EXHIBIT "A"

LIBERTY DRUG STORE
CONSTRUCTION PLANS

984 EAST 10600 SOUTH
SANDY, UTAH

REVISIONS		DESCRIPTION
REV	DATE	
1	6/8/26	CITY REVIEW COMMENTS
2	7/8/26	CITY REVIEW COMMENTS
3	7/22/26	REVISED BUILDING FOOTPRINT
4		
5		
6		
7		
8		
9		
10		
PROJECT NO: 26104		
DRAWN BY: TG		
CHECKED BY: SS		
DATE: MARCH 2026		
PROPERTY NO:		
LANDSCAPE PLANTING PLAN		
L2.01

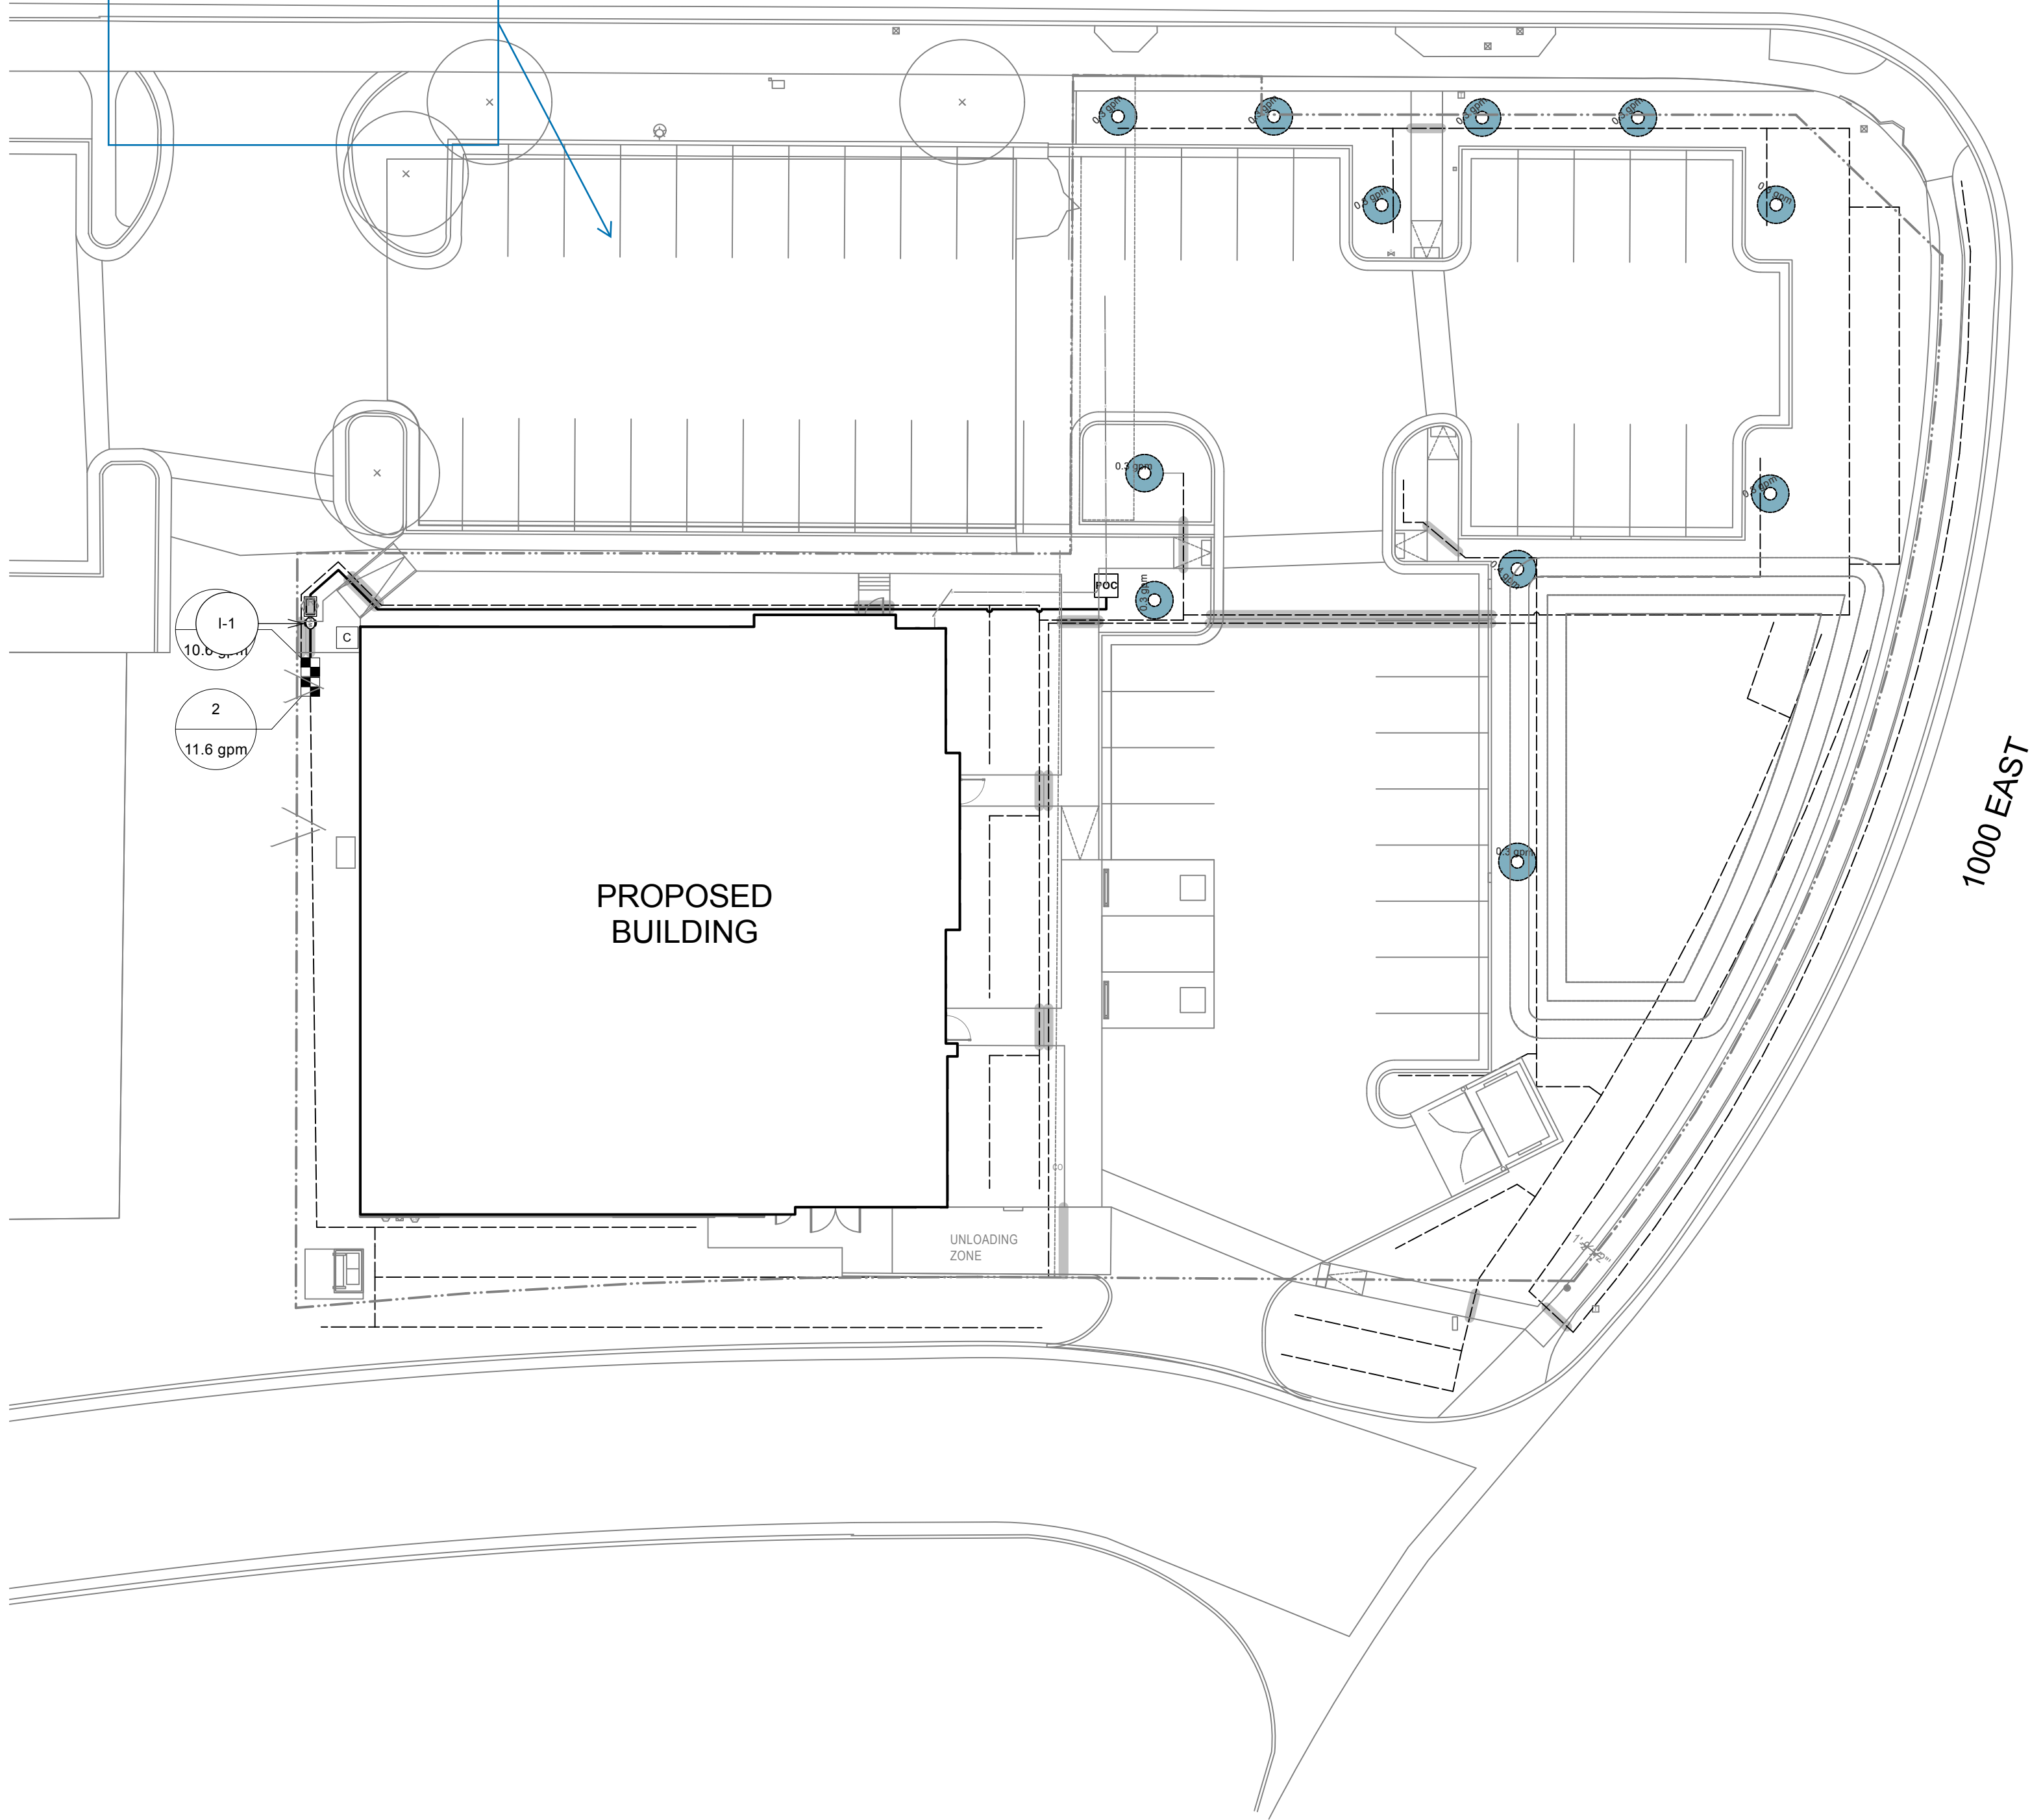
08/13/26 Code Sec 21-23-11 (c&d)
Please include photometrics for this site
